**TOWN OF MOUNTAIN VILLAGE
DESIGN REVIEW BOARD REGULAR MEETING
THURSDAY JANUARY 8 2015, 10:00 AM
2nd FLOOR CONFERENCE ROOM, MOUNTAIN VILLAGE TOWN HALL
455 MOUNTAIN VILLAGE BLVD, MOUNTAIN VILLAGE, COLORADO
AGENDA
(REVISED)**

**COMMUNITY DEVELOPMENT DEPARTMENT
PLANNING DIVISION**

Hotel Madeline
Phase 1 Remodel

Site & Pedestrian Flow Plan

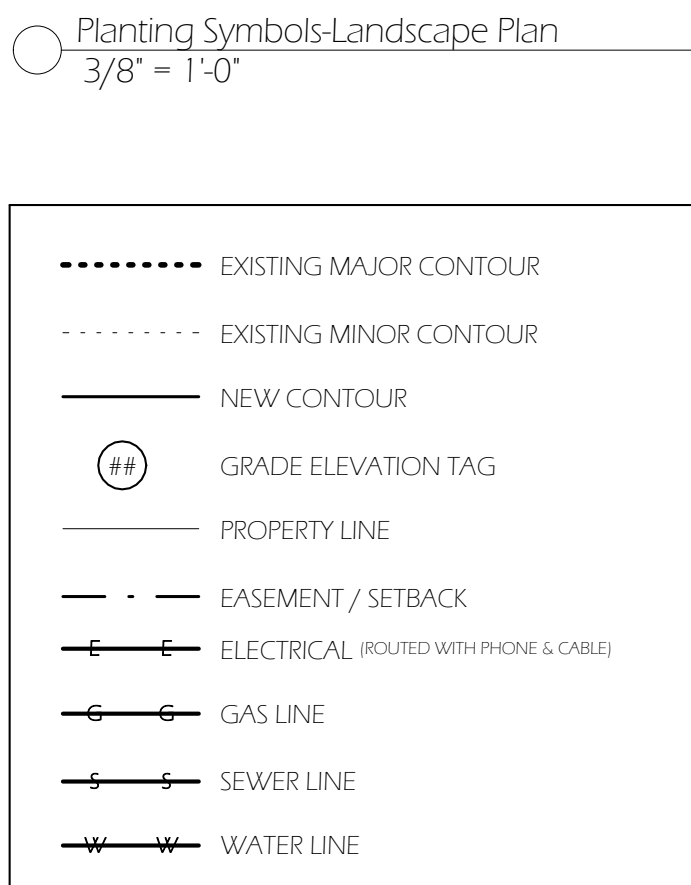
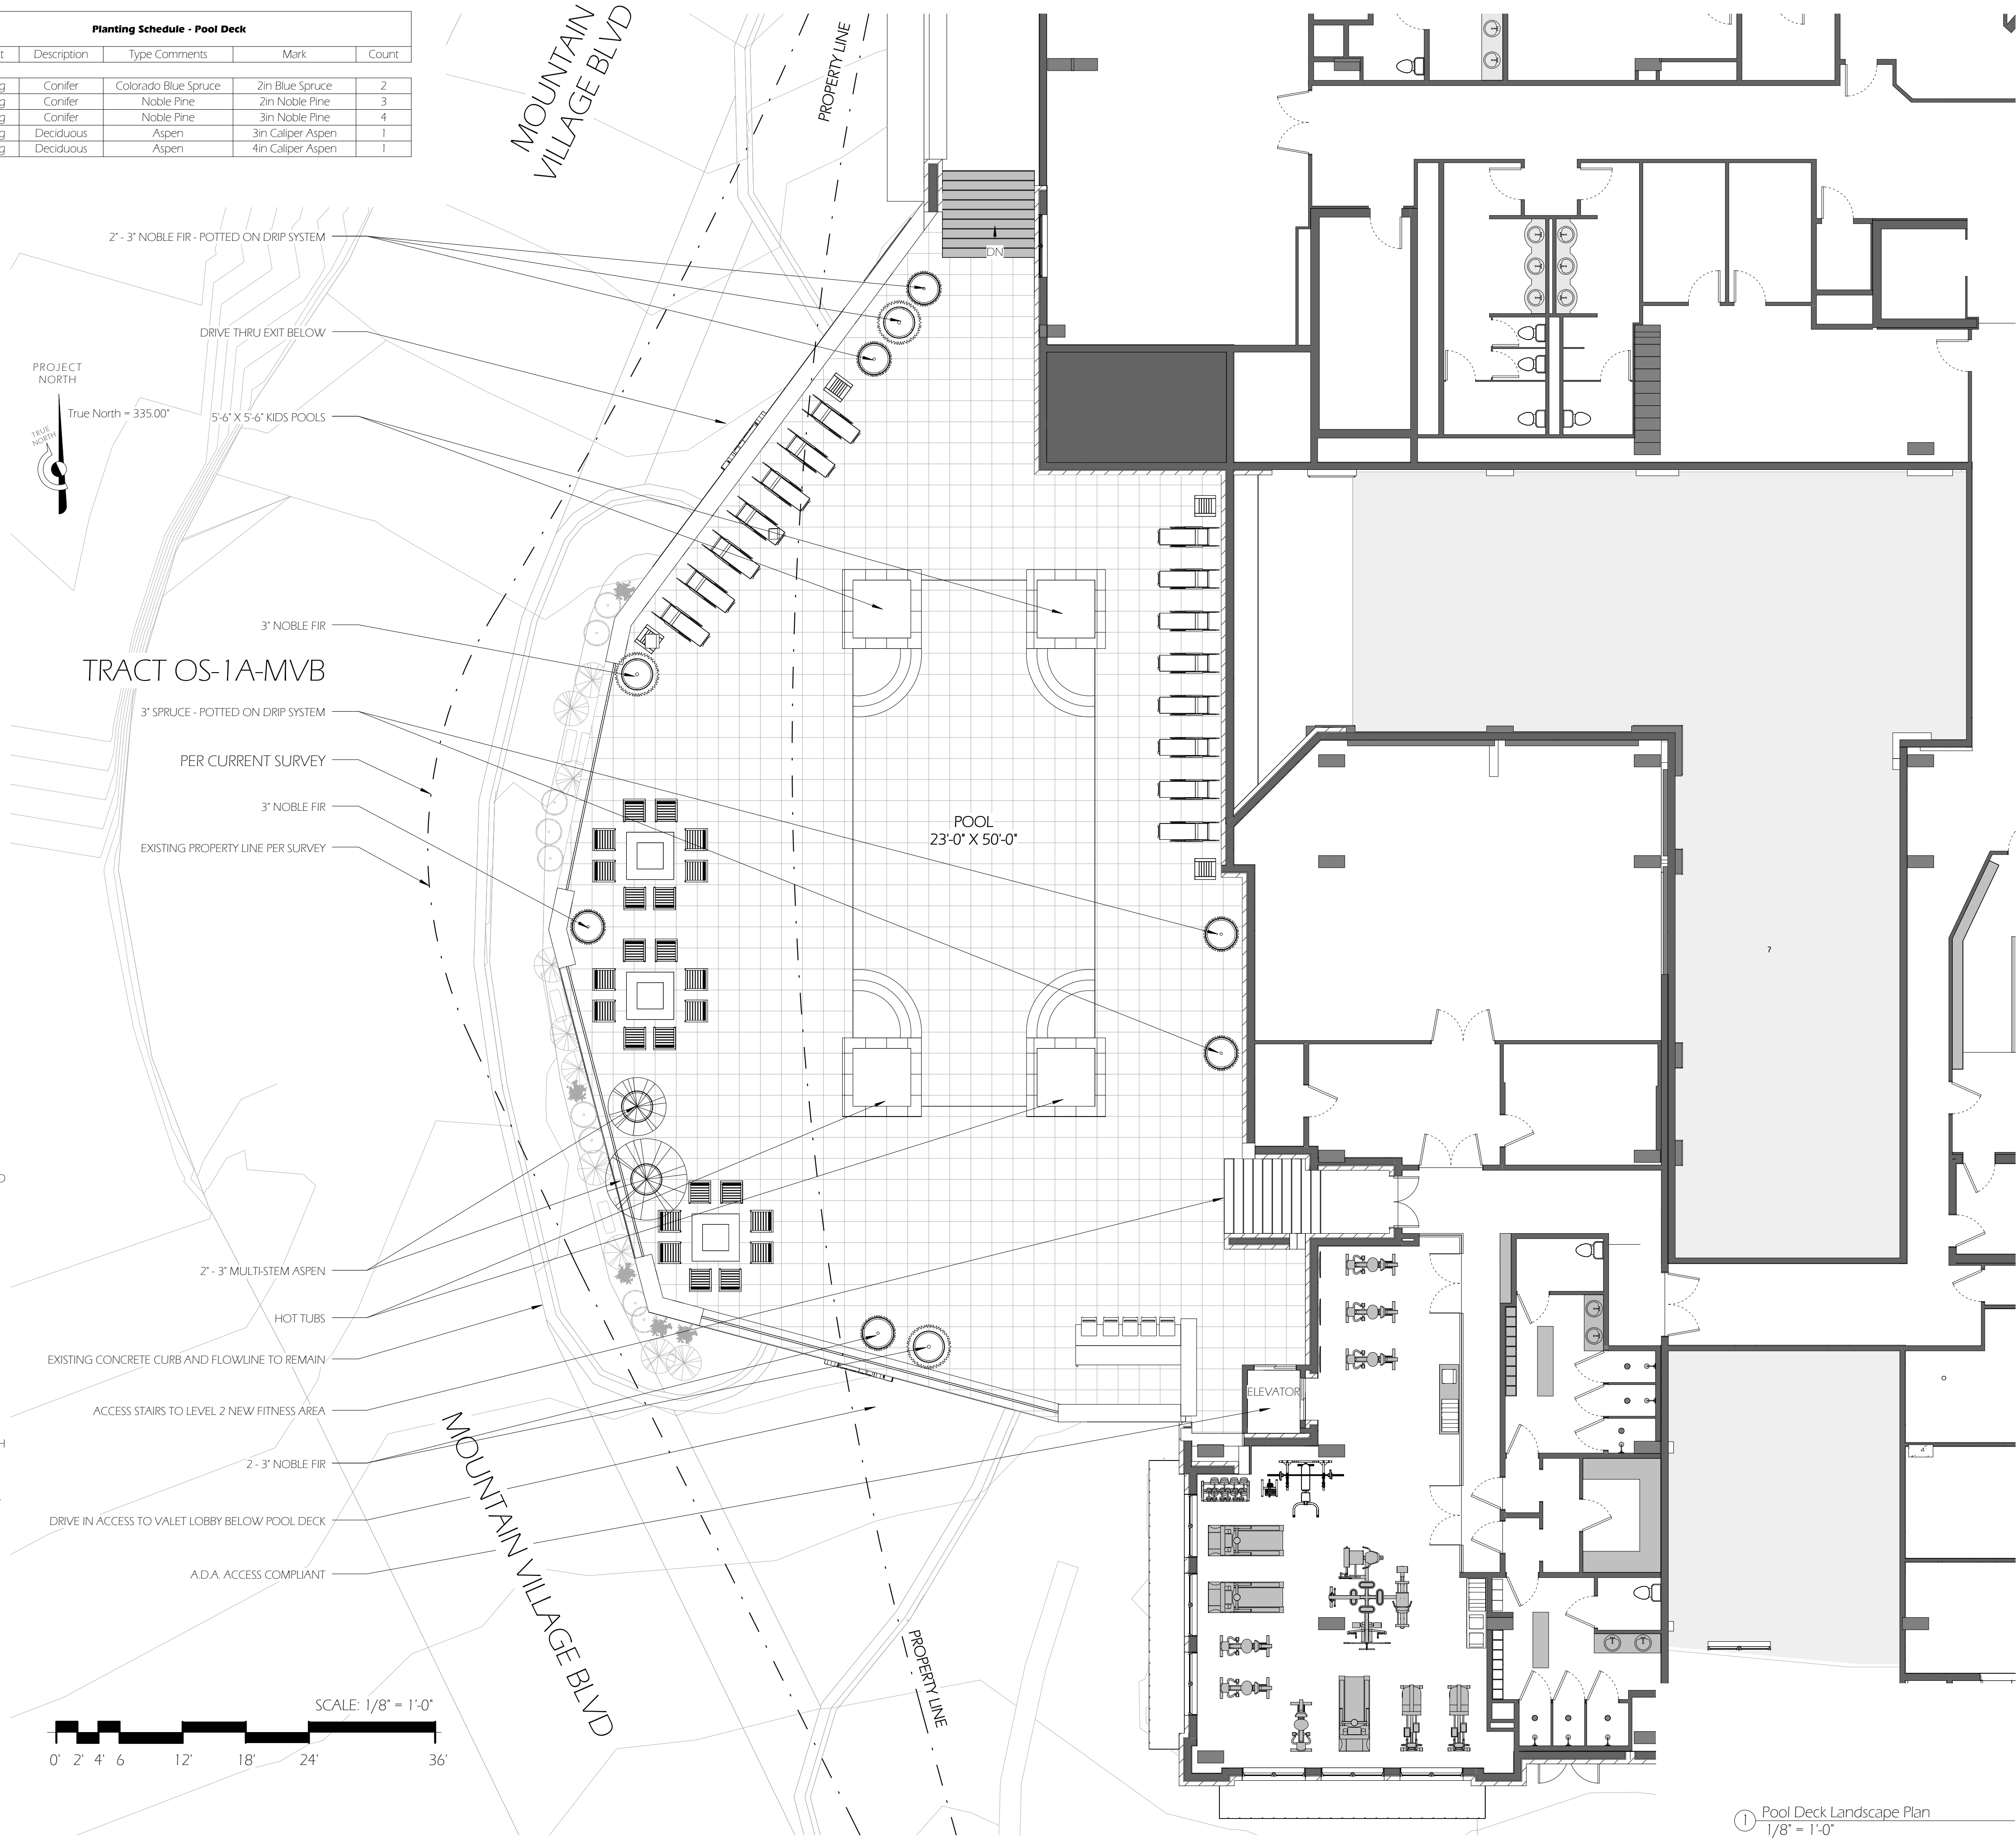
1. The sidewalk at the porte cochere egress shall be extended to provide for pedestrian line of sight for drivers exiting the porte cochere. *This condition has been met. Please refer to sheet A1.1.4. The revised site plan shows an extended sidewalk by the north*

- exit of the porte cochere that will provide very good sight distance for pedestrians and vehicles.
2. The deck drainage shall be reviewed and approved. *This condition has been met, with pool deck drainage directed to the current roof drainage infrastructure. The pool and hot tubs will have their own drainage system to the sewer system.*

Landscape Plan - Second Level Pool

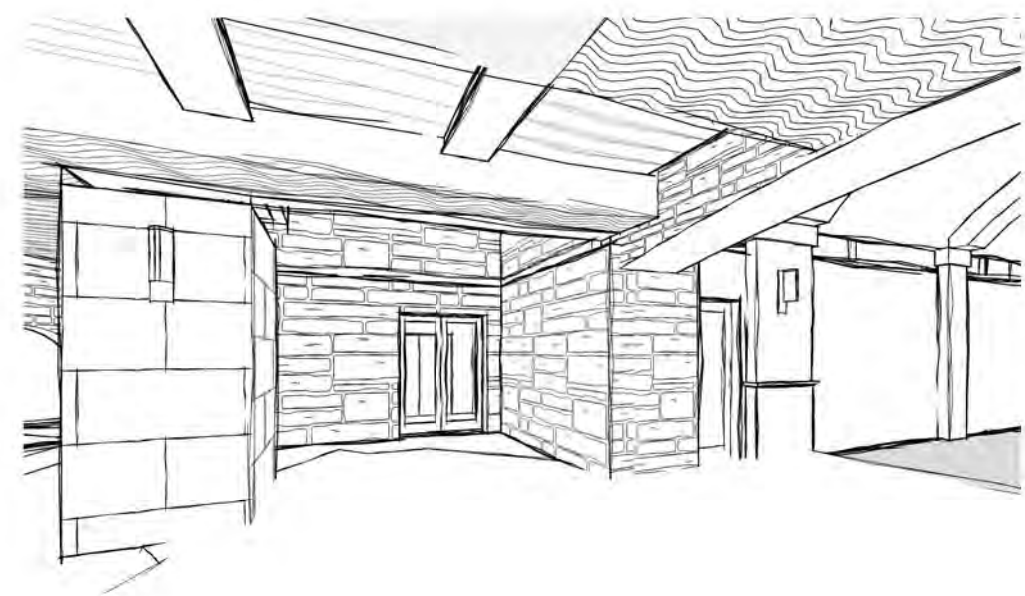
5. The landscaping plan shall be revised to include a plant legend with quantities, species, caliper and size. *This condition has been met. Please refer to sheets A1.1.6.*

Lighting Plan - First Level Portecachere

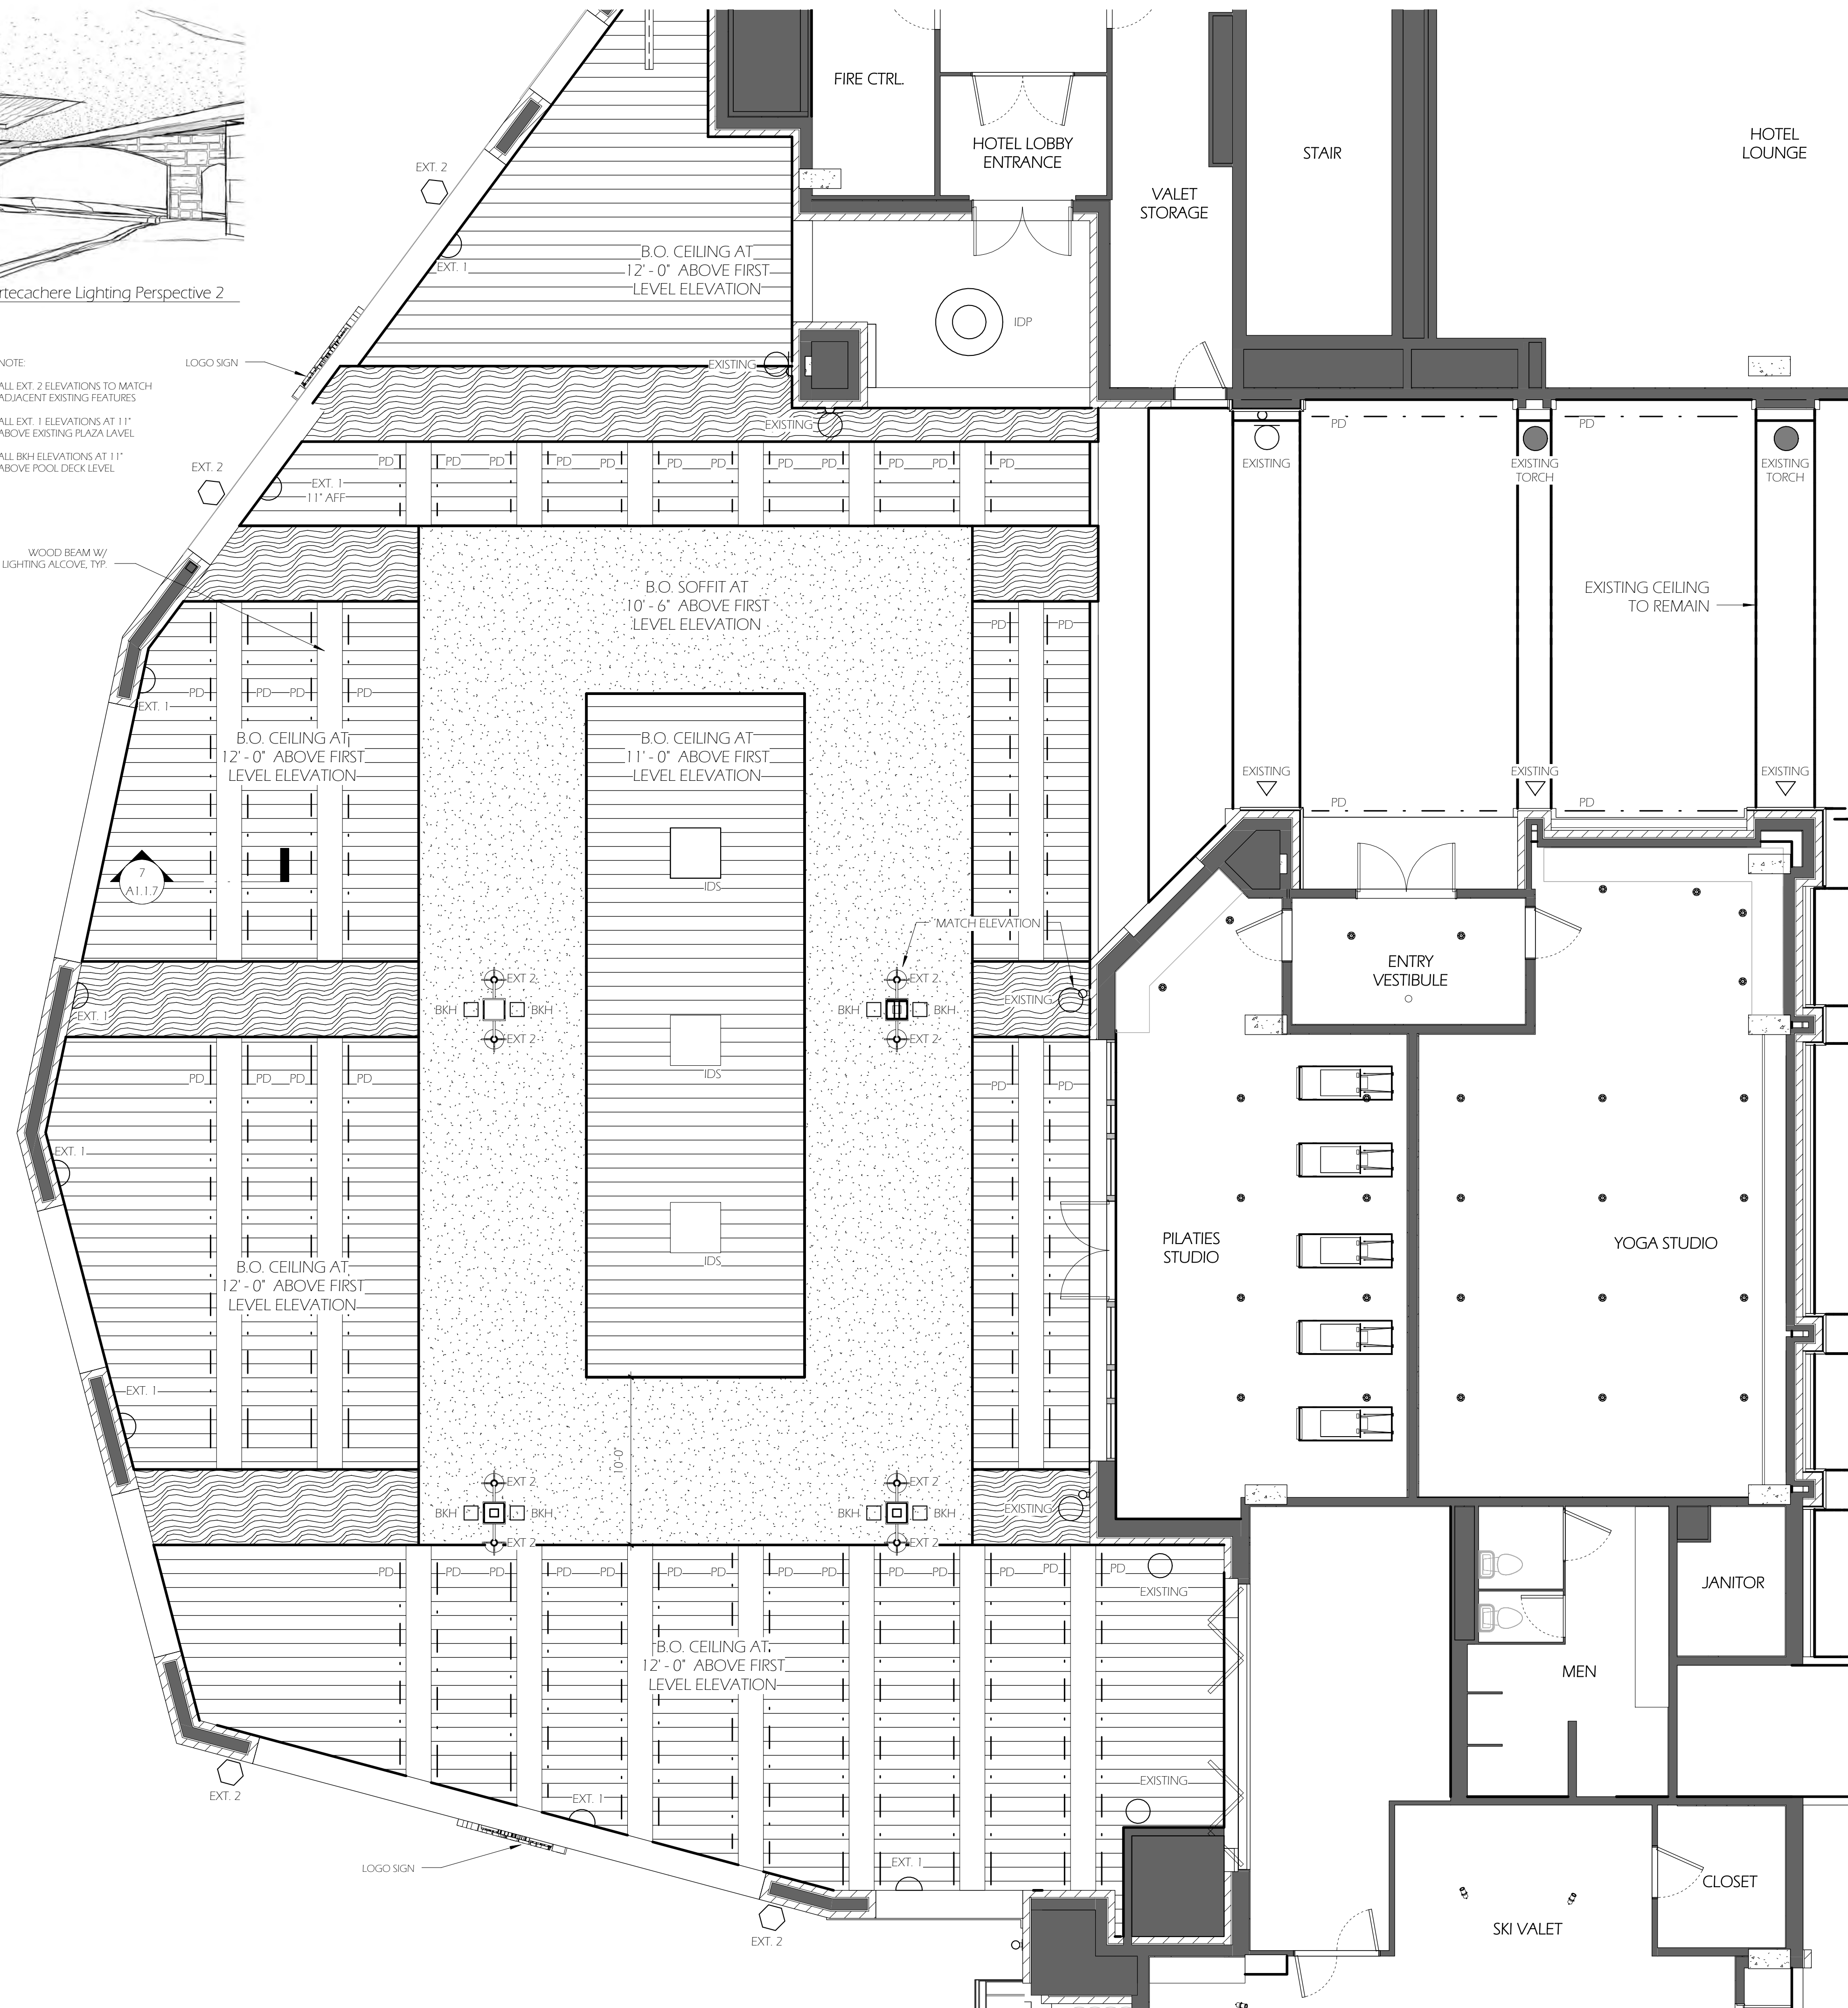
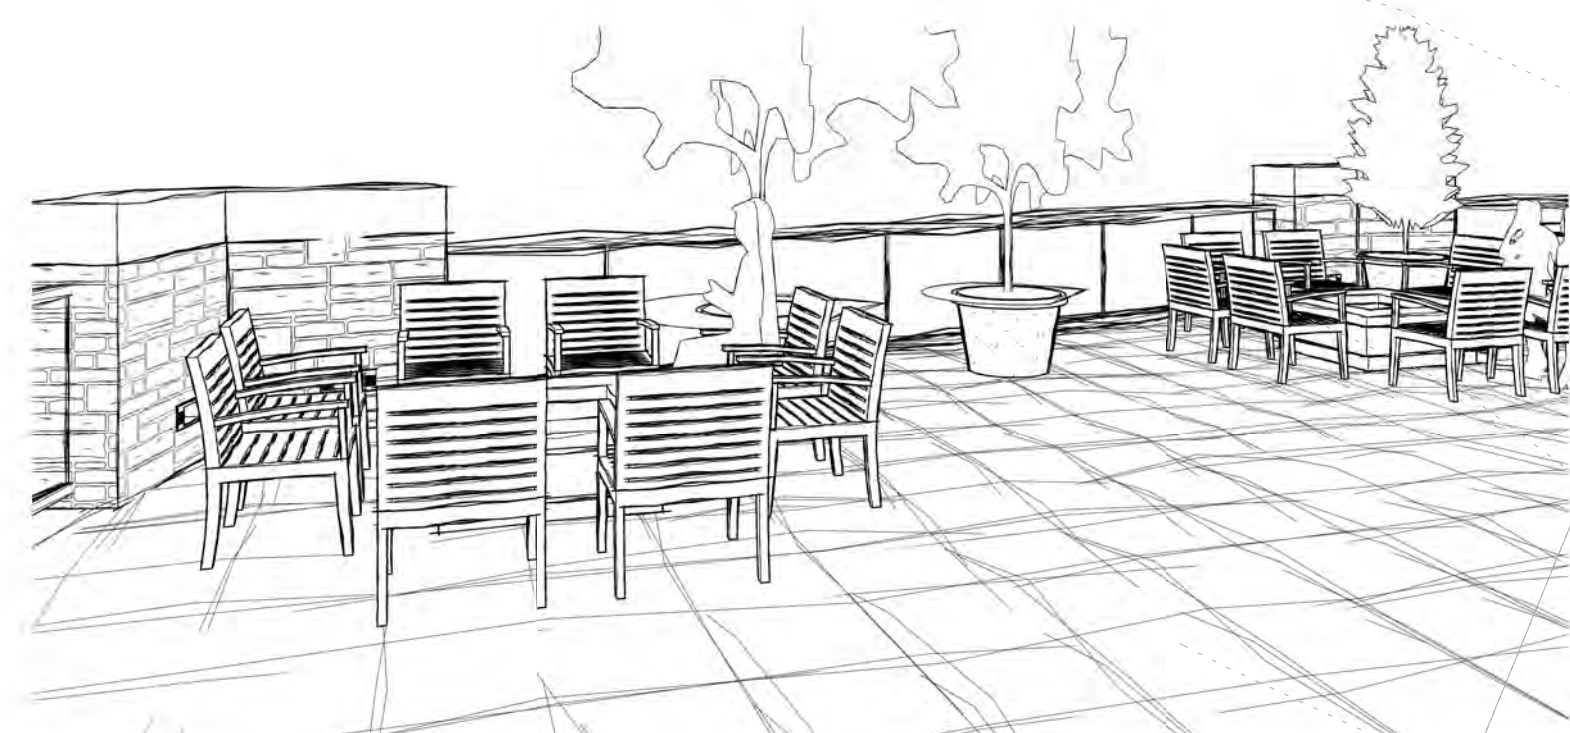
6. A lighting plan for porte cochere, pool deck and pool lighting shall be submitted in accordance with the Lighting Regulations for review and approval. *This condition has been met. Please refer to sheet A1.1.7 and A1.1.8 along with the associated lighting specification sheets. Staff has asked for clarification on the specifications for a few of the lights to ensure proper bulb temperature. The applicant's lighting designer will present the lighting plan at the meeting.*
